P.O.A.D.P.

GREEN ACRES SUBDIVISION

INFORMATION SHEET FOR
PRELIMINARY OVERALL AREA DEVELOPMENT PLAN
(P.O.A.D.P.)

RE: Green Acres POADP
(File #294)

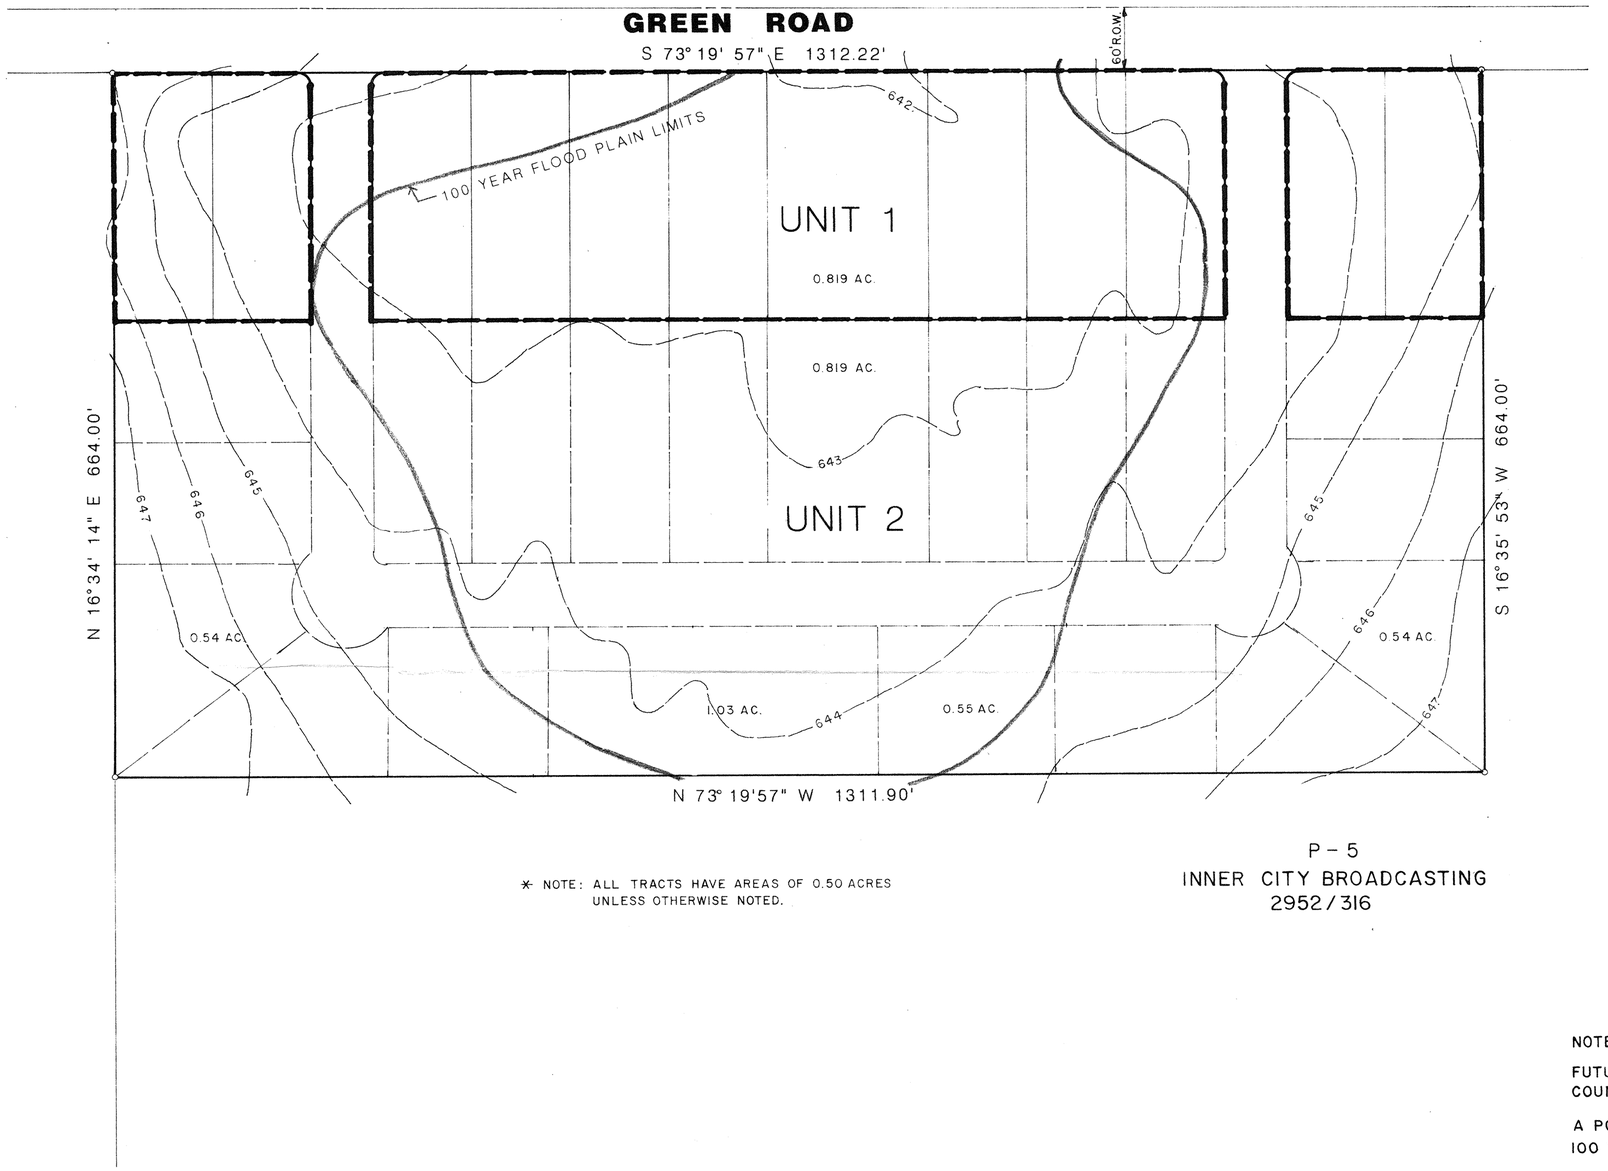
The committee accepts the plan in regards to the subdivision design; however, it does not support construction of the streets to Bexar County standards. At the time of submission, the plat will be cited for any violations to the Unified Development Code. At that time you may request the appropriate variances or revise the plat accordingly.

Committee approves the subd. design but disapprovs of the streets being built to County specs. Also mention flood plain, drainage.

According to Roberto Gonzalez, the applicant intends to develop the roadways to Bexar County standards. Elbows will be provided and variances will be requested.
